**HWY50 SEWER REPLACEMENT PROJECT
PALMER STREET AND TRACY ANN ROAD
SANITARY PLAN AND PROFILE**

C2.1

HWY50 SEWER REPLACEMENT PROJECT
PALMER STREET AND TRACY ANN ROAD
SANITARY PLAN AND PROFILE C2.4

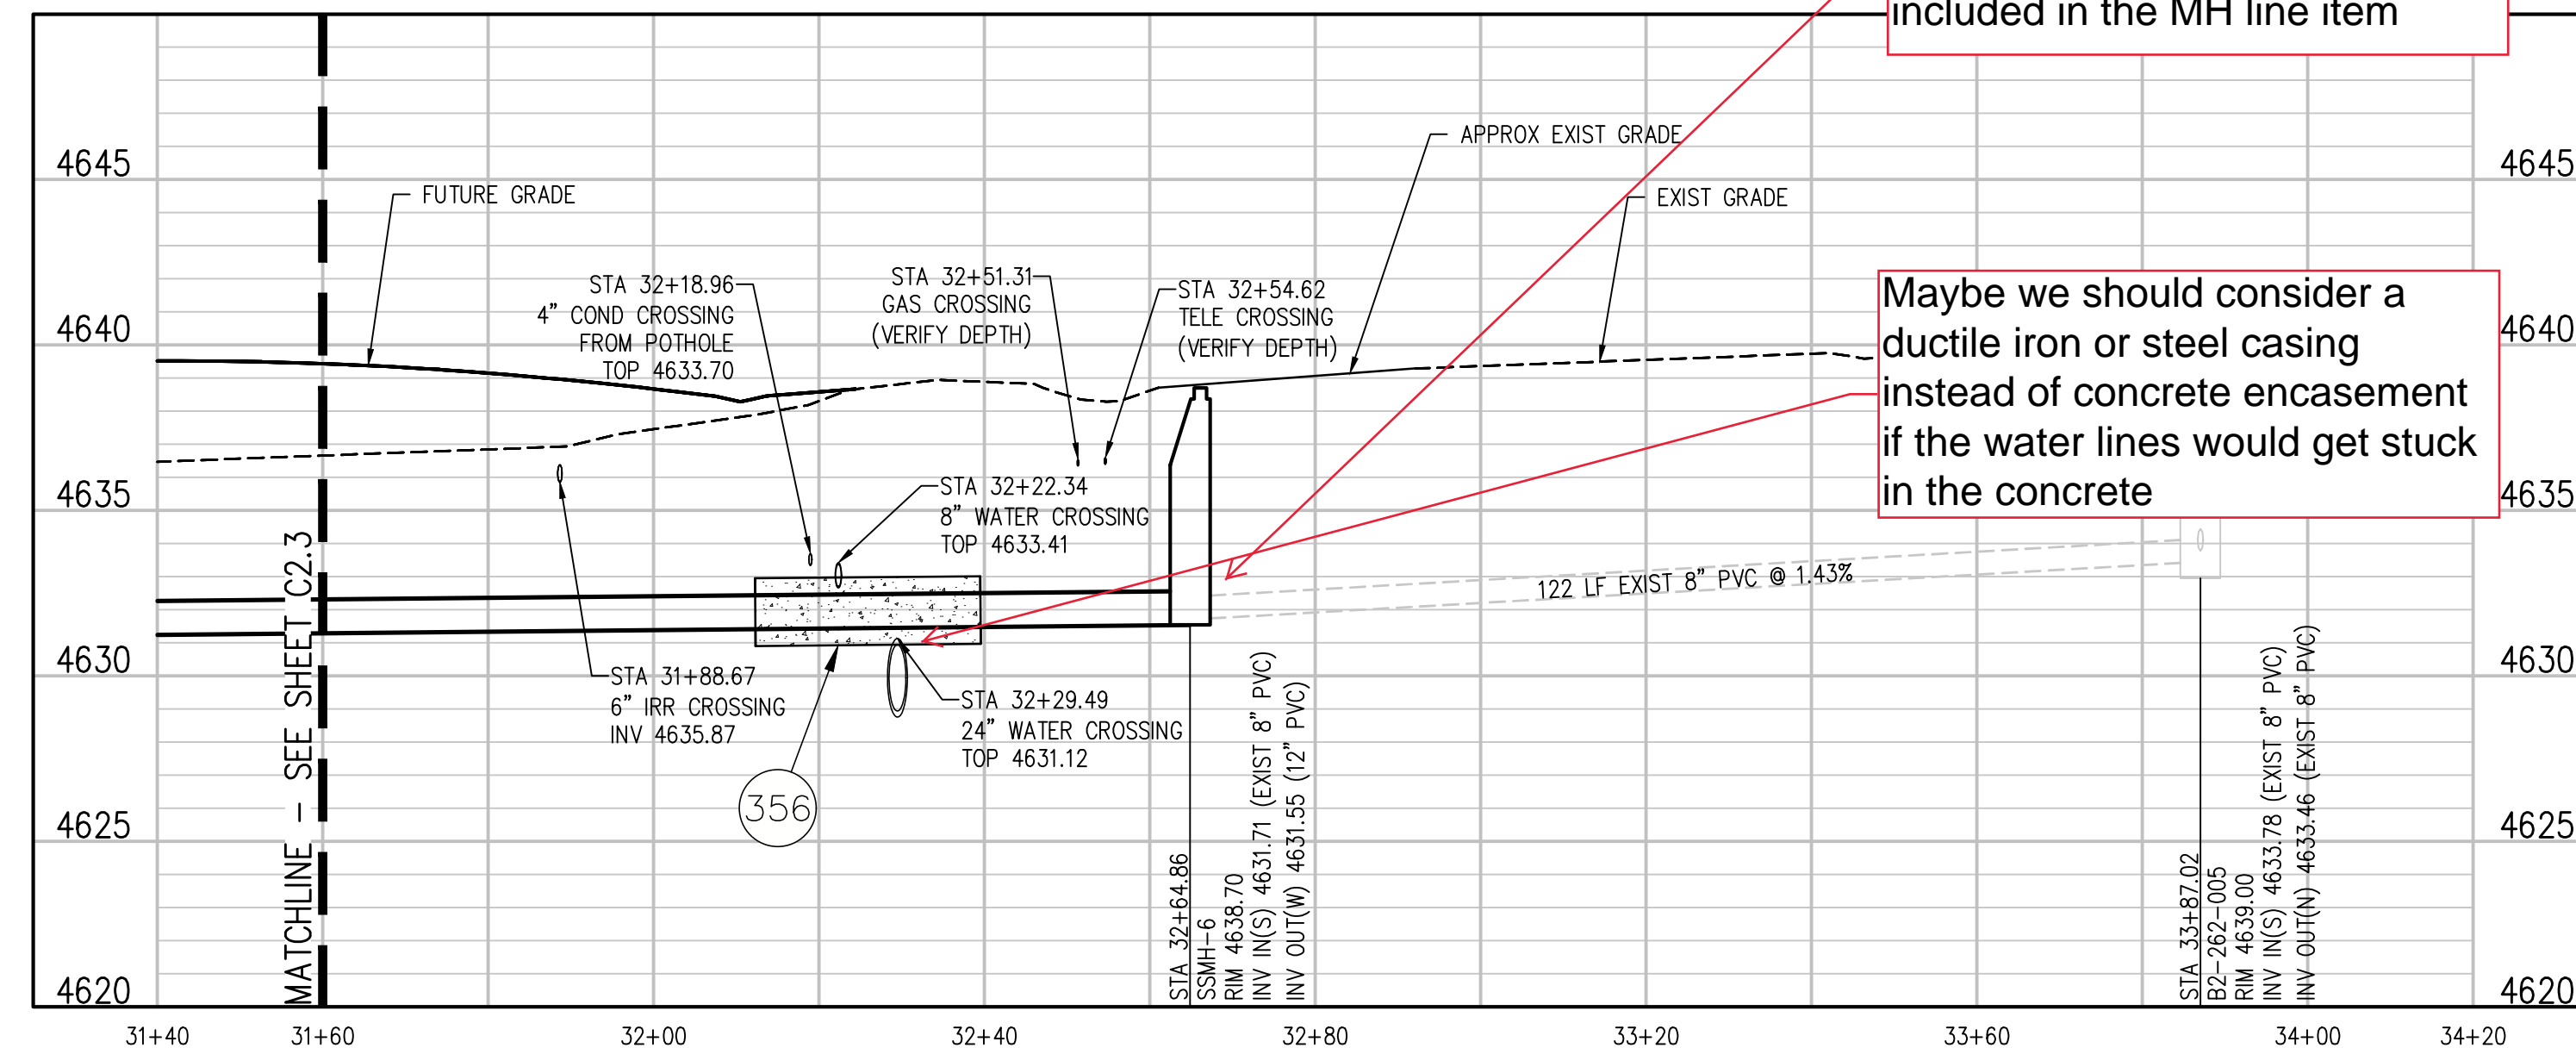
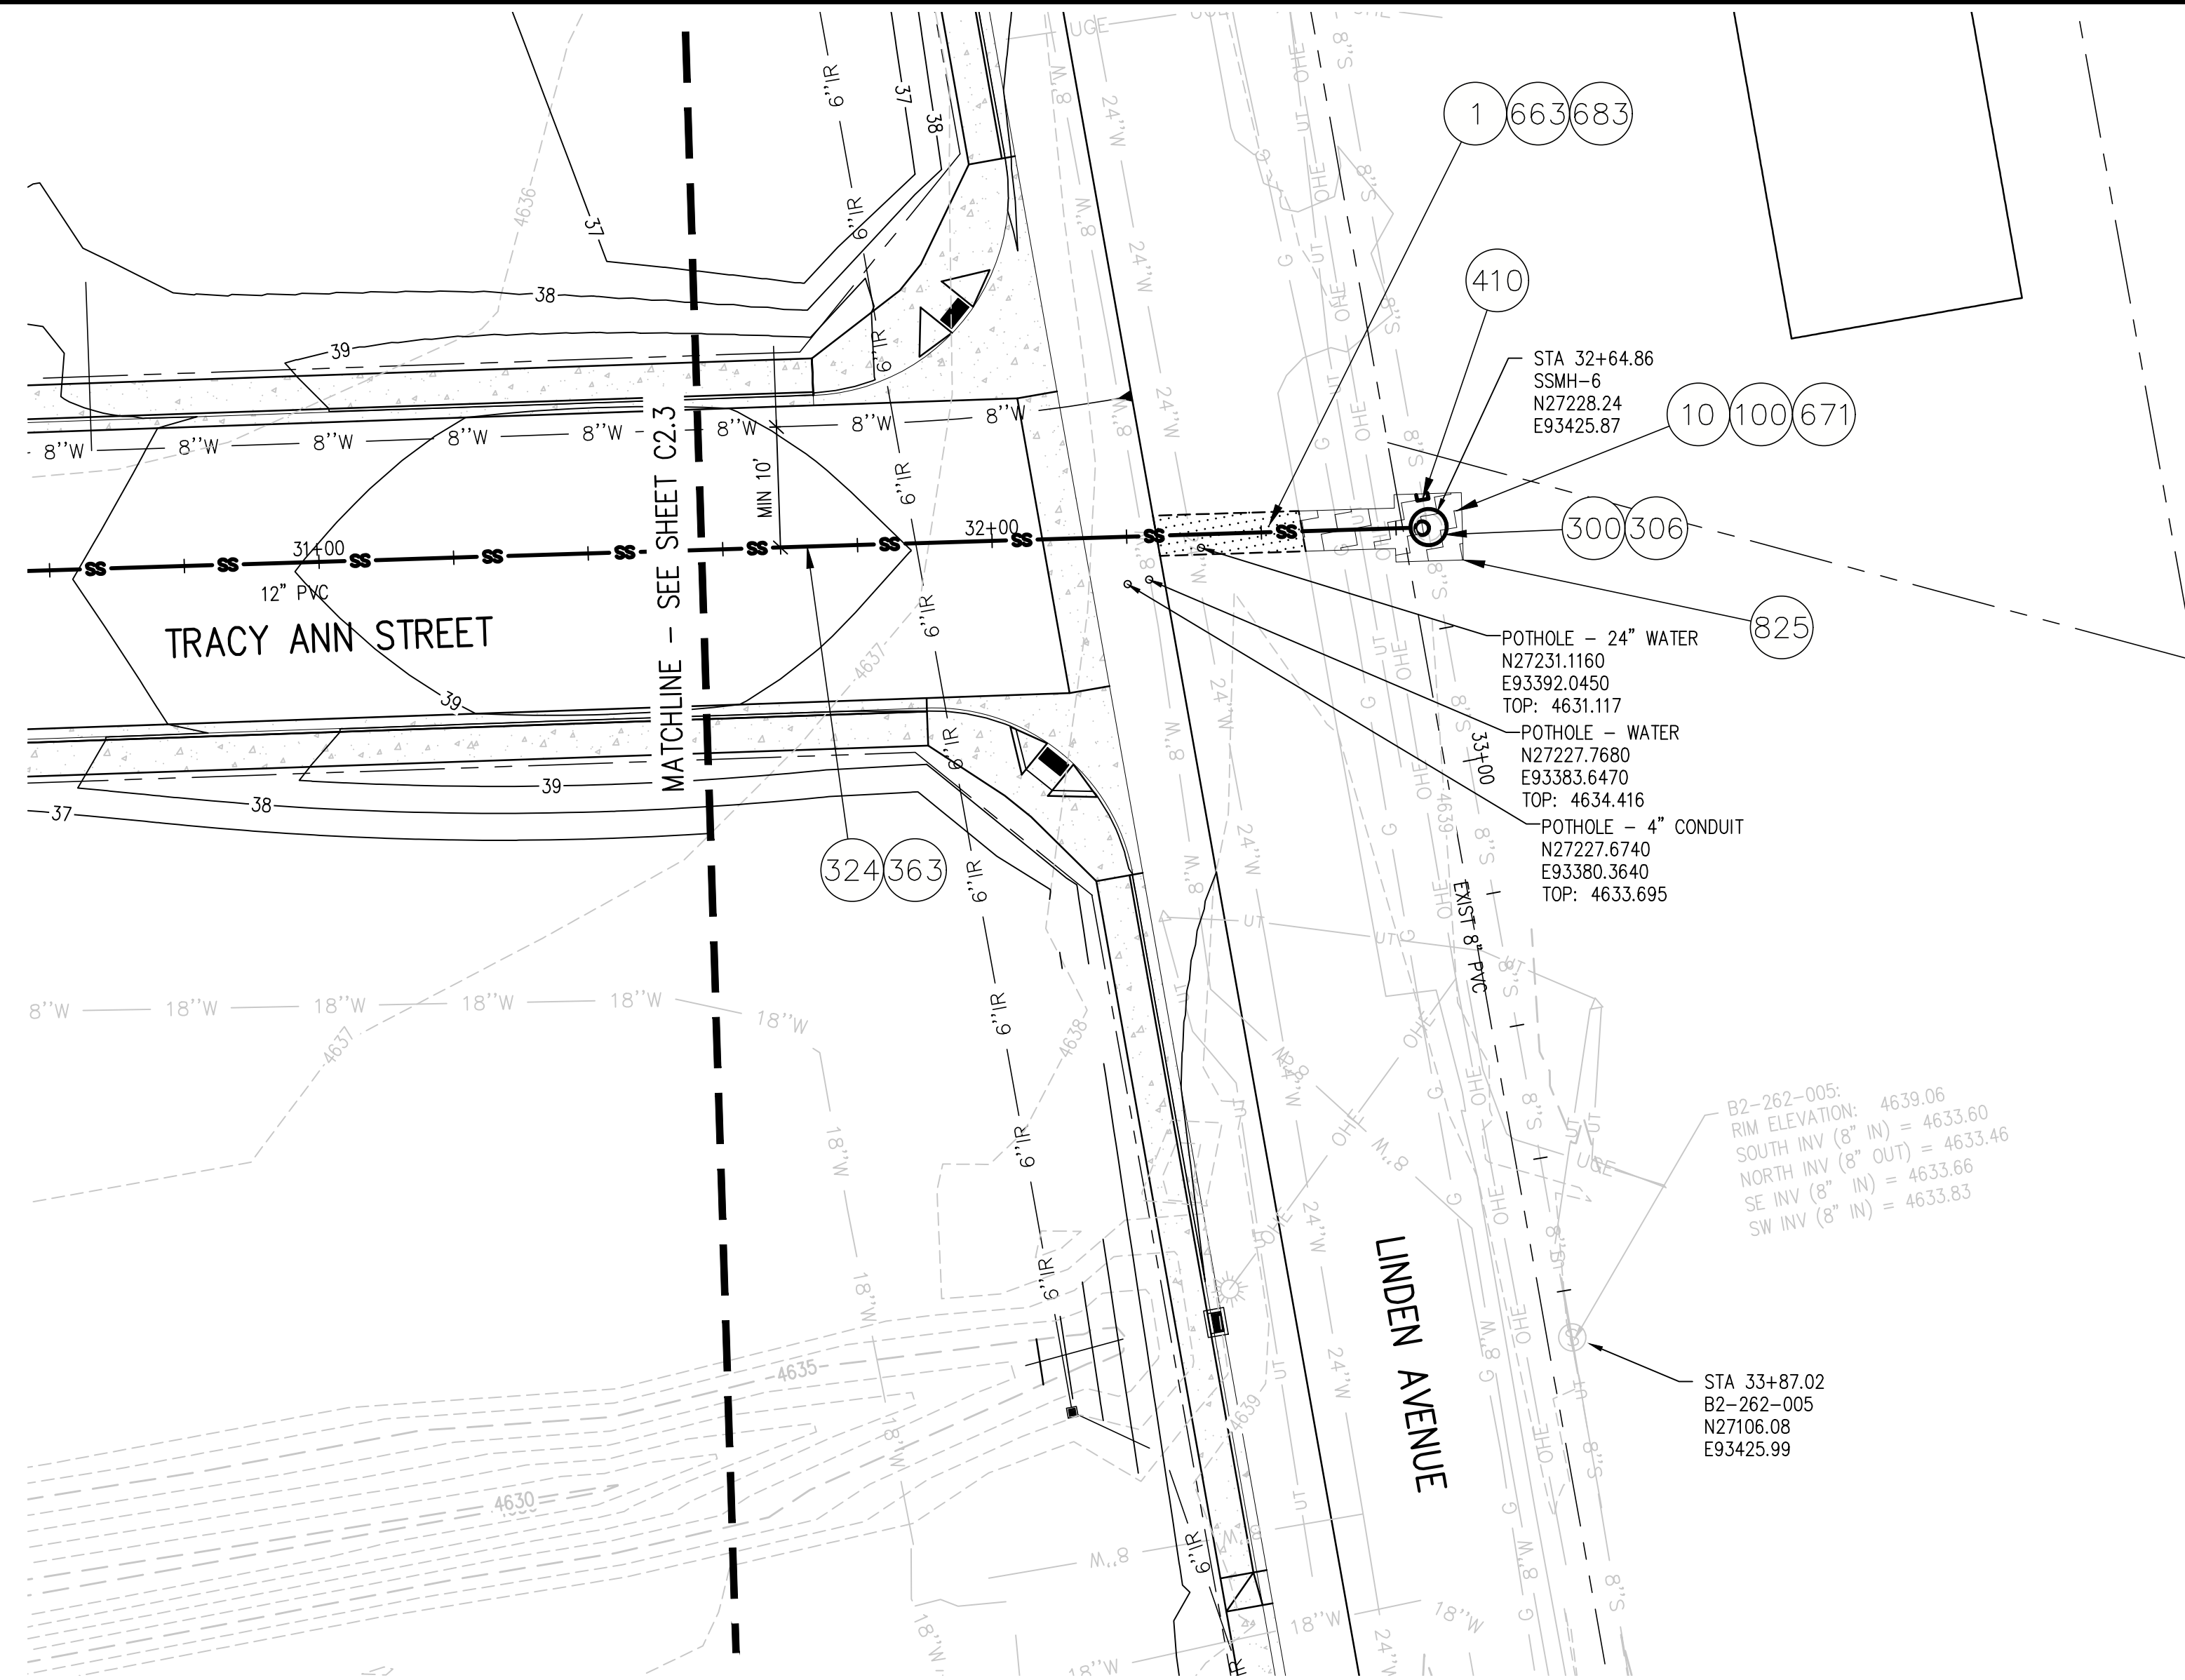
Add in line item for connection to existing sewer, if not already included in the MH line item

Maybe we should consider a ductile iron or steel casing instead of concrete encasement if the water lines would get stuck in the concrete
